Access Compliance Report

Public Rights-of-Way (Curb Ramps)

Intersection ID: 18484	Main Street: FOXCROFT_WOODS_LN	Cross Street: SHARON_RD	Location: NE
ADA ID: A50BCF7B4F1A	Ramp Type: PerpDiag	Initial Pass/Fail: Fail	Overall Compliance: No
Severity Score: 17.5			
Codes/Mitigation Info/Possible Solution		Field Measurements/Component Compliance

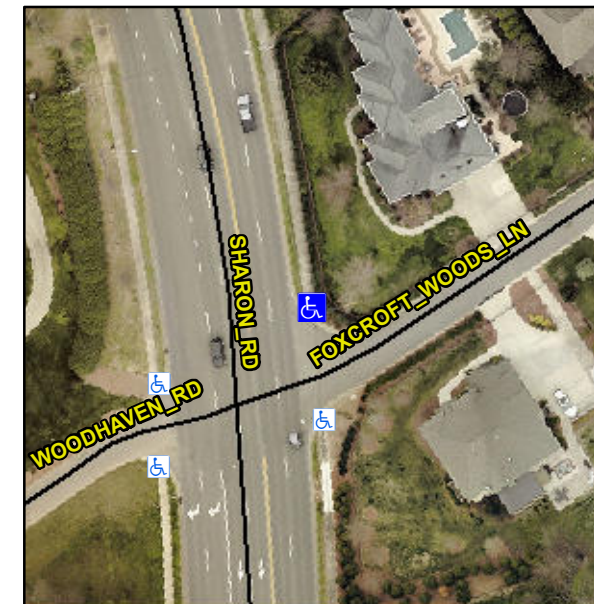
Compliance	Description	Data	Compliance	Description	Data
N/A	Ramp Length (in)	29.5	Yes	Ramp Slope (%)	6.5
No	Ramp Width (in)	35.0	Yes	Ramp XSlope (%)	1.3
N/A	Flare Type LT	N/A	N/A	Flare Type RT	N/A
N/A	Flare Slope LT (%)	N/A	N/A	Flare Slope RT (%)	N/A
N/A	Flare Traversable LT?	N/A	N/A	Flare Traversable RT?	N/A
N/A	Landing Length (in)	N/A	N/A	DWS Provided?	N/A
N/A	Landing Width (in)	N/A	N/A	DWS Contrast?	N/A
N/A	Landing Slope (%)	N/A	N/A	DWS Length (in)	N/A
N/A	Landing X Slope (%)	N/A	N/A	DWS Full Width?	N/A
N/A	Landing Curb? (Y/N)	N/A	N/A	DWS Offset (in)	N/A
N/A	Shared Landing?	N/A			
N/A	Gutter Ponding?	N/A	N/A	Gutter Slope (%)	N/A
N/A	Gutter Lip Ht (in)	N/A	N/A	Gutter X Slope (%)	N/A
N/A	Painted X Walk1?	No	N/A	Painted X Walk2?	No
	X Walk 1 Direction	To W		X Walk 2 Direction	To S
N/A	X Walk 1 Width (in)	N/A	N/A	X Walk 2 Width (in)	N/A
	X Walk 1 Slope (%)	4.3		X Walk 2 Slope (%)	0.5
	X Walk 1 X Slope (%)	1.6		X Walk 2 X Slope (%)	2.2

Remove & Replace Curb Ramp With Two New Directional Ramps or Equivalent.
